Order Instituting Rulemaking to Consider
Alternative-Fueled Vehicle Programs,
Tariffs, and Policies.

Rulemaking 13-11-007
(Filed February 23, 2018)

**MARCH 21, 2018 OPENING COMMENTS OF THE JOINT PARTIES ON ASSIGNED
COMMISSIONER’S RULING SEEKING COMMENT ON VEHICLE-INTEGRATION
COMMUNICATION PROTOCOL WORKING GROUP ENERGY DIVISION STAFF
REPORT**

Figure 2: Diagram of AC Communications Pathways

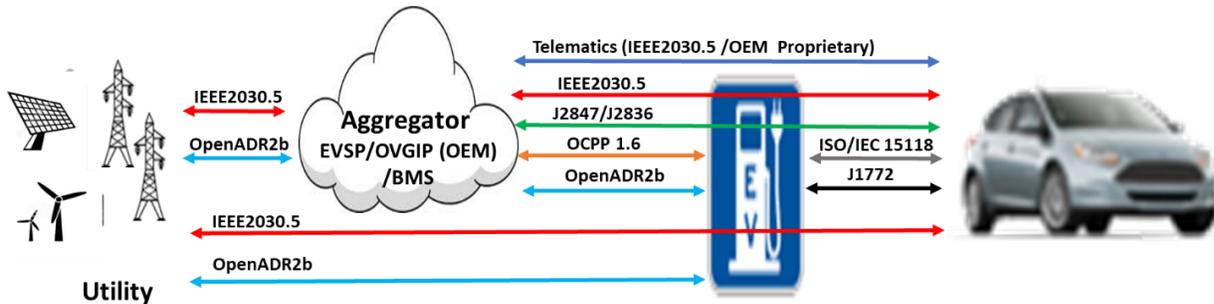
- **Figure 2 should be deleted and replaced with the correct version**

The Joint Parties include a revised version of Figure 2 “Diagram of AC Communications Pathways,” below, which accurately reflects a summary of the Mapping Sub Working Group member’s graphical representations of the specific protocols. The Joint Parties request that the current Figure 2 be deleted because it does not adequately show that IEEE 2030.5 is bridged (or routed) through the EVSE or aggregator without the need for it to be decrypted and translated to another protocol. In addition, Figure 2 only addresses communications pathways for AC Level 2 Conductive Charging protocol applications and should be labeled accordingly. DC Charging communications protocols such as IEEE 2030.1.1 are not addressed.

Note: Line through the EVSE means EVSE is acting as a bridge for the protocol to the EV – provides a pass through of the messages without translation, encryption and decryption
